EPC STORMWATER REVIEW COMMENTS
IN ORANGE BOXES WITH BLACK TEXT

TRAILS AT ASPEN RIDGE FILING NO. 4

FINAL GRADING & EROSION CONTROL PLANS

AUGUST 2021

TRAILS AT ASPEN RIDGE			
FILING NO.4 GRADING & EROSION CONTROL PLANS			
GRADING & EROSION CONTROL PLAN			
DESIGNED BY: BAS	SCALE: 1" = 50'	DATE ISSUED: AUGUST 2021	DRAWING No. GEC01
DRAWN BY: BAS	HORIZ. N/A	SHEET 4 OF 8	
CHECKED BY: NMS	VERT. N/A

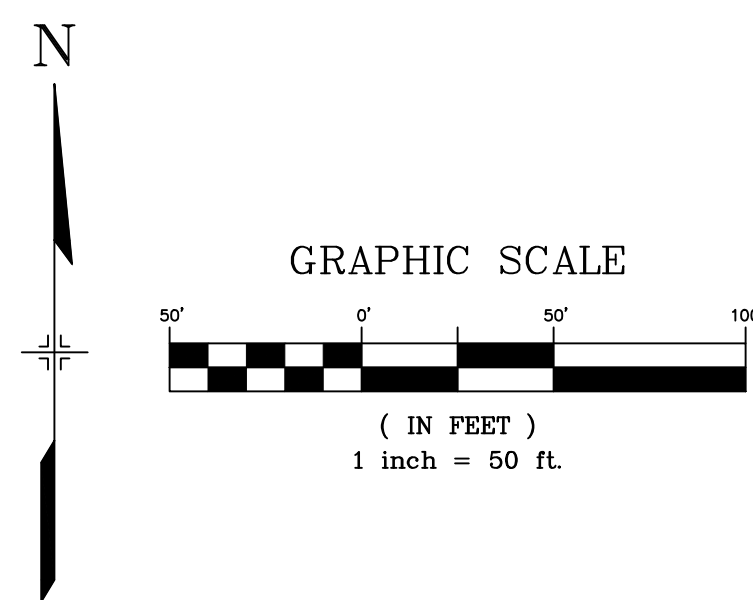
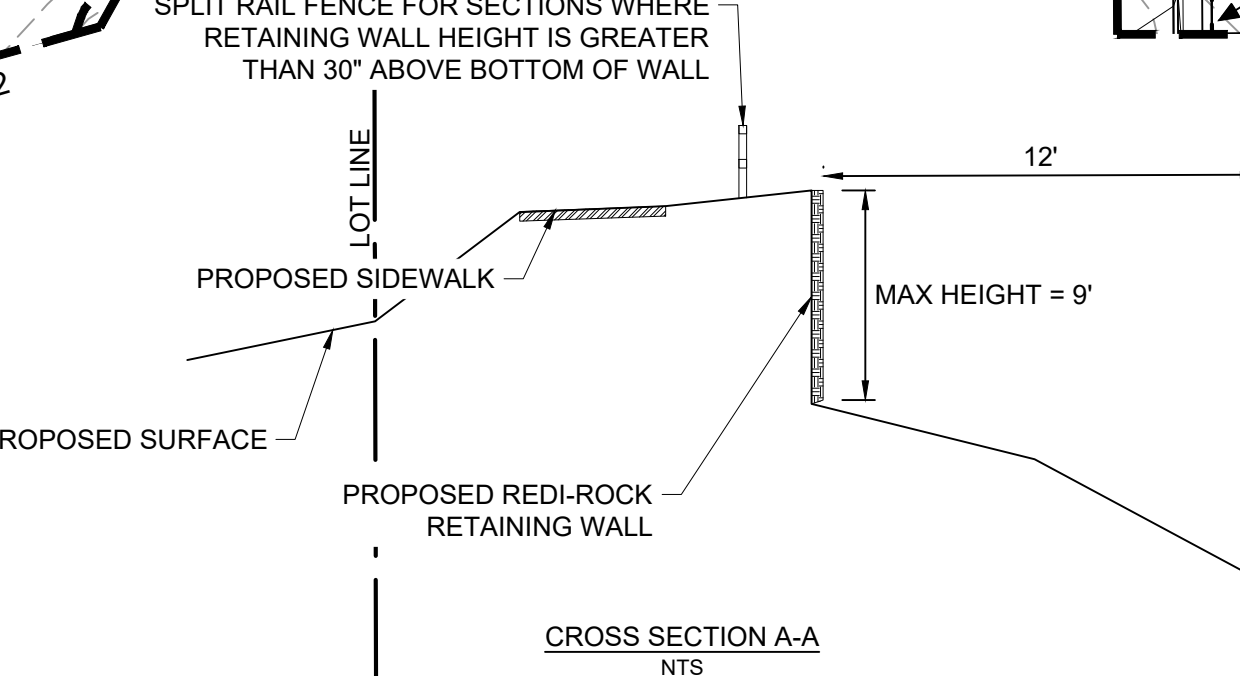
INCLUDE "J-HOOK" WHEN SILT FENCE GOES PERPENDICULAR TO CONTOURS PER DETAIL

show/label rough cut steel control on plans, legend, and detail on last sht.
